PHOTOGRAPHS

PHOTOGRAPH #13

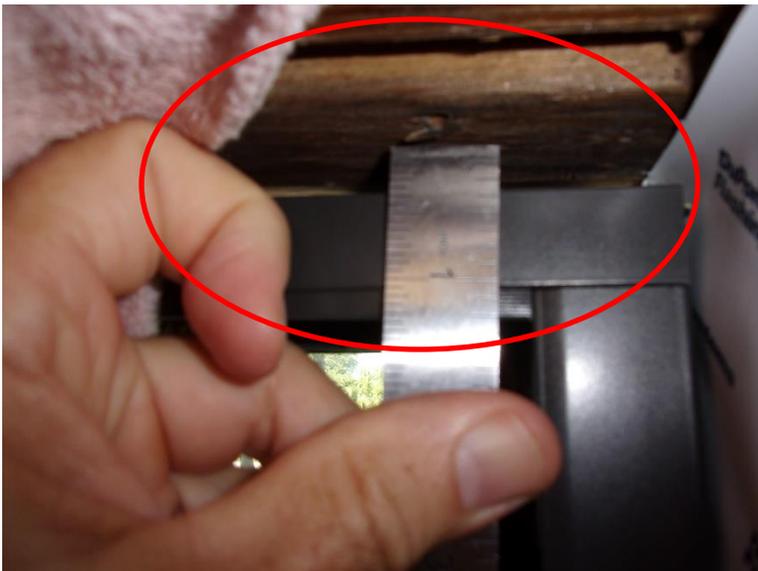
Windows inspected at unit interior for compliance with PGT NOA requirements and Dupont/ Tyvek flashing requirements.

PHOTOGRAPH #21

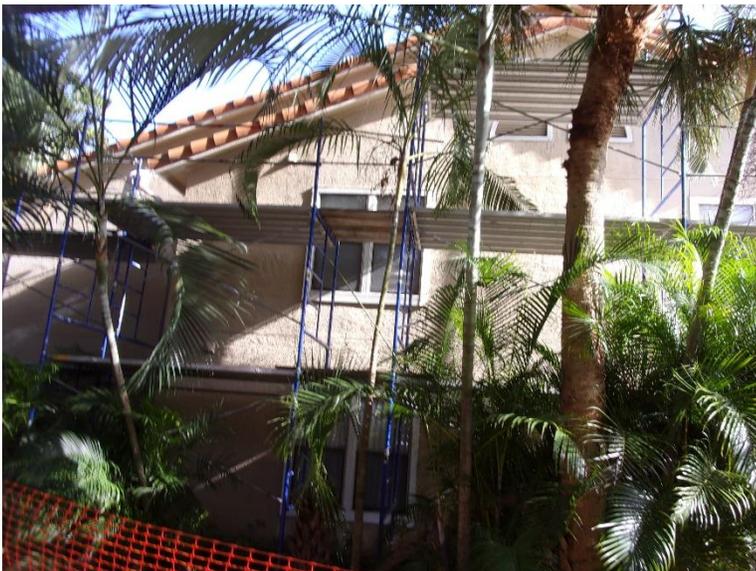
Contractor installing plywood sheathing using pressure treated 15/32" at bottom sheet.
